HISTORIC AND DESIGN REVIEW COMMISSION

HDRC CASE NO: 2020-146

ADDRESS: 803 N CHERRY

PUBLIC PROPERTY: Future Berkley V. and Vincent M. Dawson Park

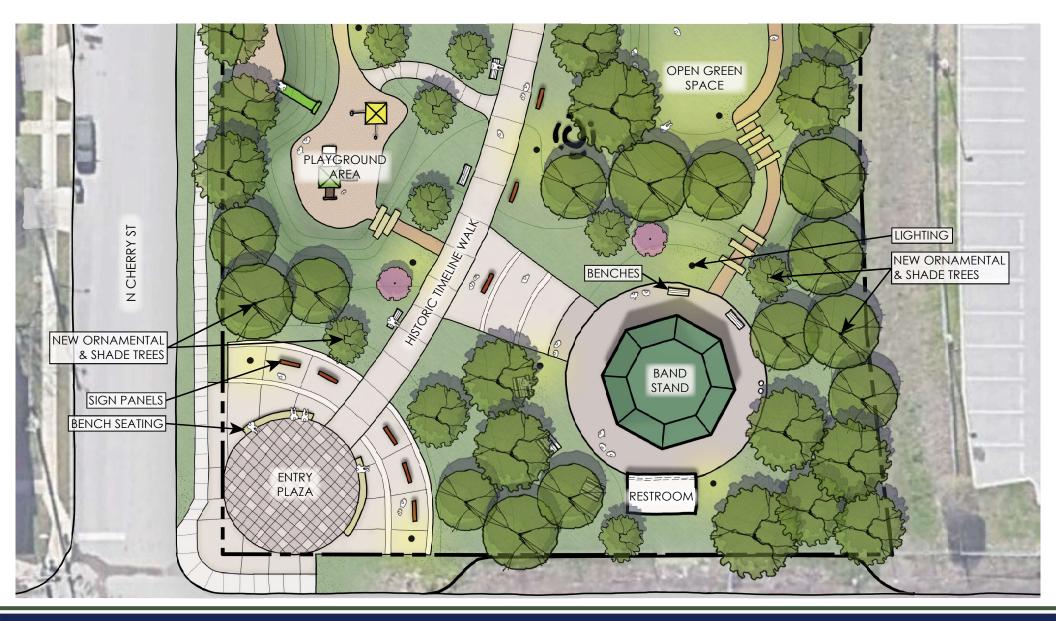
- c. SIGNAGE The applicant has proposed to install signage in the proposed park. Sign panels are currently proposed outside of the entry plaza and along the walkway referred to as the Historic Timeline Walk. UDC Sec. 35-642(b)(7) stipulates that signs which are out of keeping with the character of the environment in question

should not be used. Excessive size and inappropriate placement on buildings results in visual clutter. Signs should be designed to relate harmoniously to exterior building materials and colors. Signs should express a simple clear message with wording kept to a minimum. Staff finds the proposal to install signage generally consistent with the UDC Sec 35-642.
